From: [Miller, Ed](#)
To: ["RILEY, Jim"](#)
Subject: Comments on dam failure white paper
Date: Tuesday, October 09, 2012 11:50:00 AM
Attachments: [Dam Failure Rev B 9-10-12_Wahl comments 2012-10-02.docx](#)

POST-FUKUSHIMA NEAR-TERM TASK FORCE RECOMMENDATION 2.1
Supplemental Guidance for the Evaluation of Dam Failures

Figure 2- Dam Breach Menu Options in HEC-HMS

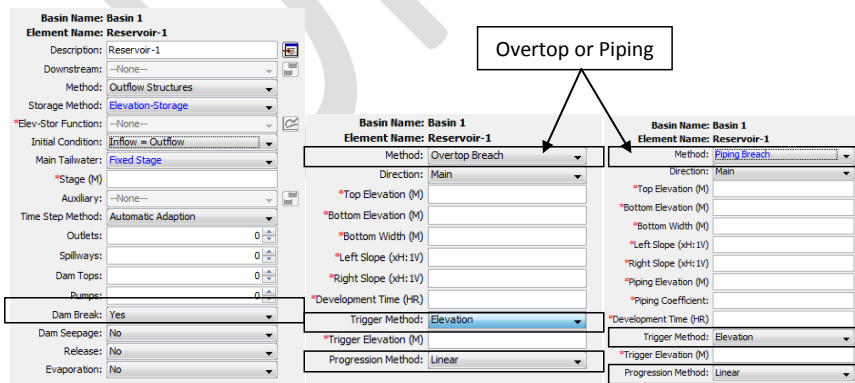
Comment [TLW13]: I think it would be helpful to define this time, so that it does not get confused with breach initiation time. Wahl 1998 offered definitions for these terms.

Figure 4 - Breach Hydrographs for Oros Dam (Gee, 2008)

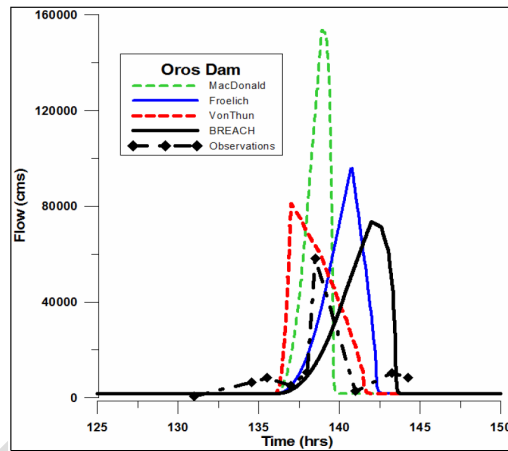
Comment [TLW27]: Gee listed all of these in his paper, but I think the only one he really used was 1995b. The 1987 paper was Froehlich's first set of breach parameter equations. The 1995a reference in your list (Gee reversed "a" and "b") was a set of peak-flow regression equations. The 1995b reference was Froehlich's revision of his breach parameter equations. Gee only appears to have tested breach parameter eqs and then fed the breach parameters to HEC-RAS to see the resulting hydrographs. I presume he would have used the most recent equations (1995b). (Froehlich also updated his breach parameter eqs again in 2008.)

Figure 9 – Distance/Height of Dam Plot

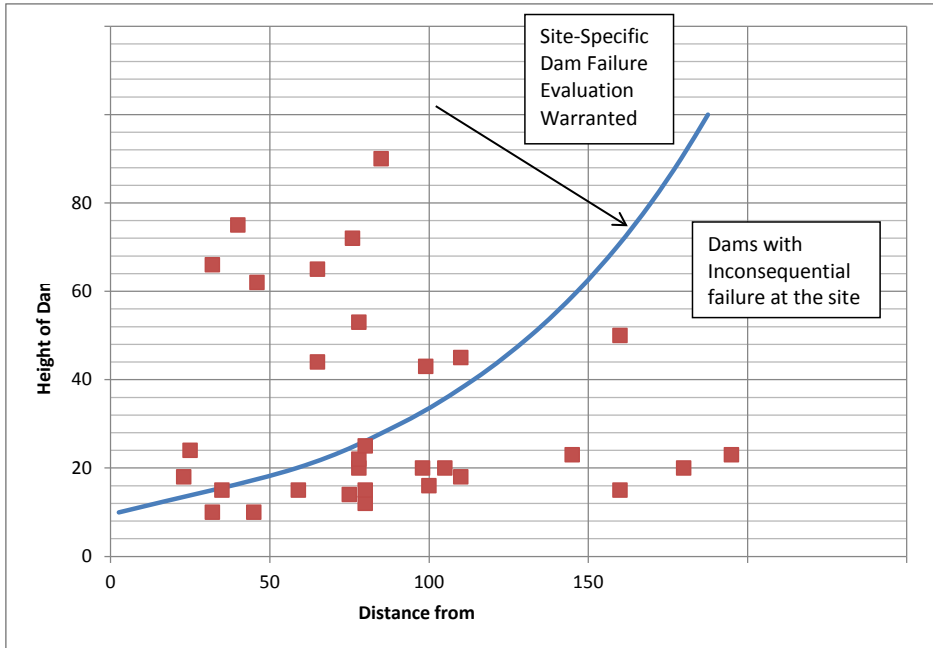
Comment [g55]: Possibly move to an appendix.

Describe limits of scope of applicability (downstream distance, dam height, etc...) and reflect limits in figure.

Comment [g56]: What is the definition of Q_p

Comment [g57]: What is the definition of Q_r

Comment [g58]: Needs further development to address this issue; define limits in example application of USBR equations.

Add example for multiple dams and zones.

Comment [g59]: Possibly move to an appendix.

Describe limits of scope of applicability (downstream distance, dam height, etc...) and reflect limits in figure.
